## SERVICE BULLETIN LA-V75-001

Product: Underground VHF Line Amplifier

Subject: Updated “live wiring” guidelines

Figure 1: Illustration of the BDA PCB, highlighting the components that are affected.

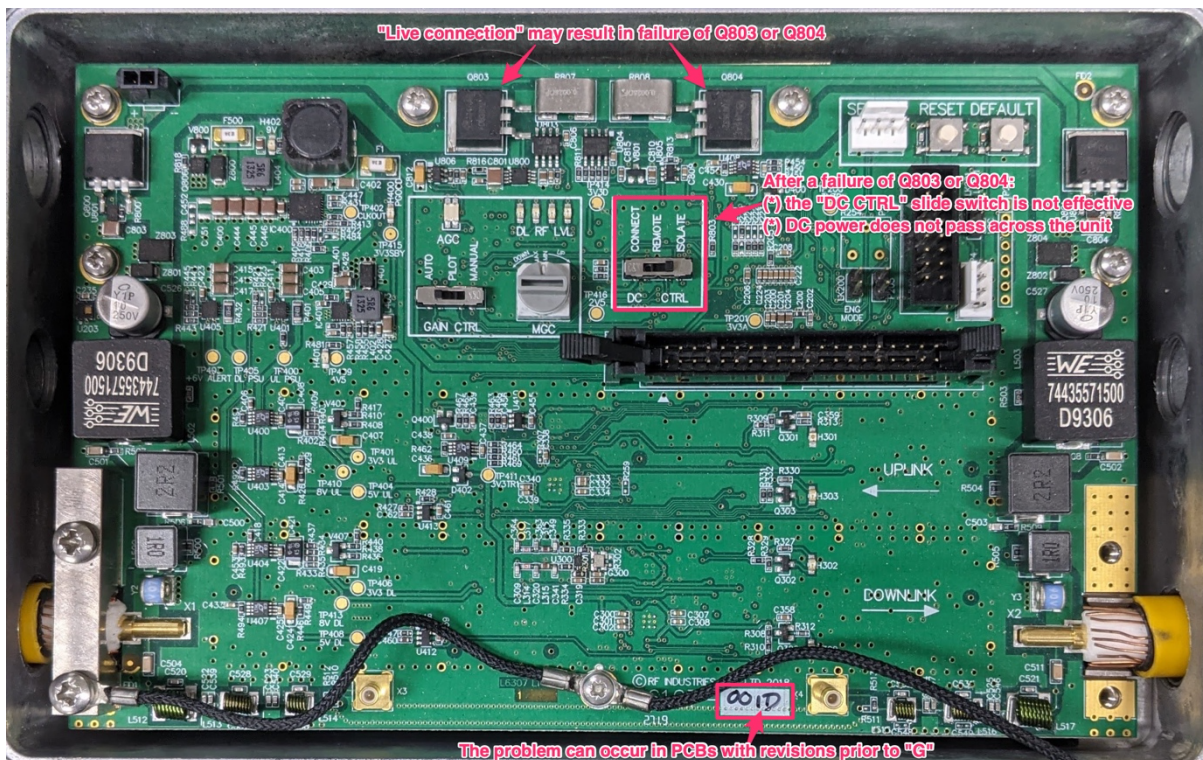
Two sites have reported failures with LineAmps after performing live connections into powered leaky feeder systems. In both instances it was found that the DC pass-through power transistor (Q803) failed. The impact on the LineAmp functionality after such a failure is:

1. The device no longer passes DC between its left and right ports;
2. The “DC CTRL” slide switch is no longer effective.

Figure 2: Illustration of the BDA PCB, highlighting the running changes implemented in mid-2020.

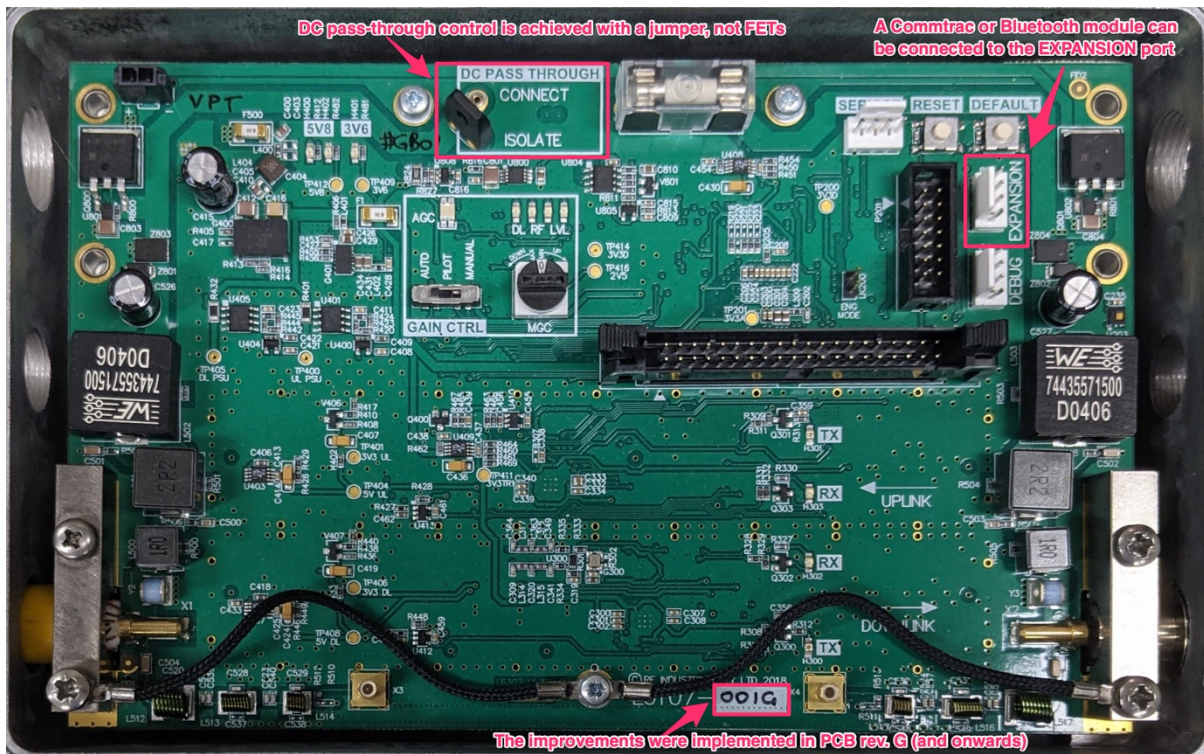
Coincidentally, a running design change was made to the BDA board design in mid-2020, which reduced the LineAmp's total power consumption and simplified the electronics. This simplification of the electronics resulted in:

- The power pass-through transistors and “DC CTRL” slide switch being replaced by an 8A jumper link;
- 40% reduced power consumption (achieved by running the internal rails at lower voltages);
- Improved labelling of PCB controls;
- Addition of the EXPANSION port (for connection of Bluetooth or tag reading modules).

These changes were implemented in PCB revisions G and onwards, as illustrated below.

Due to the removal of the FETs, BDA PCBs with revision G (and onwards) do not suffer from this issue.

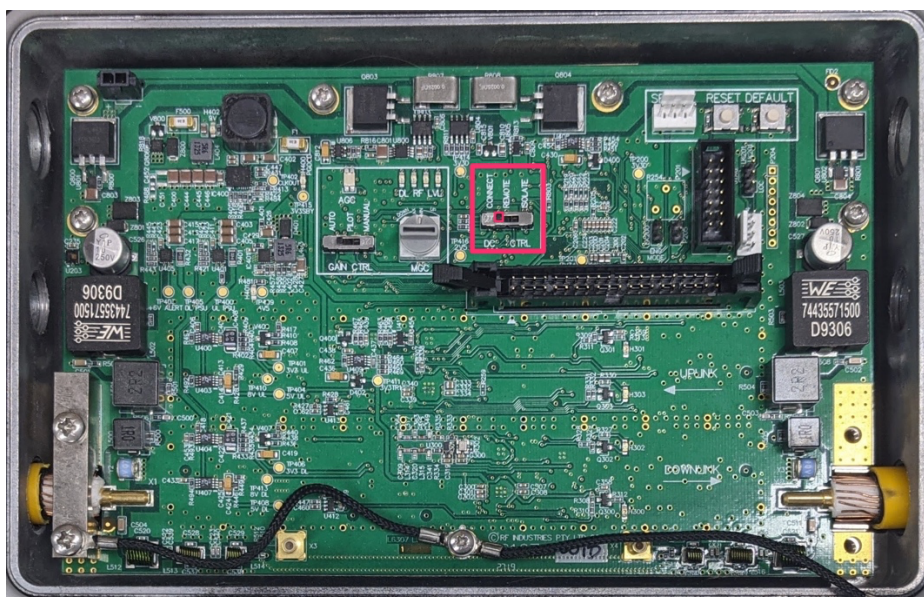
Select the ISOLATE position prior to “wiring live”

1. Before wiring a LineAmp into a powered leaky feeder system, place the DC pass-through control into the **ISOLATE** position as shown below.
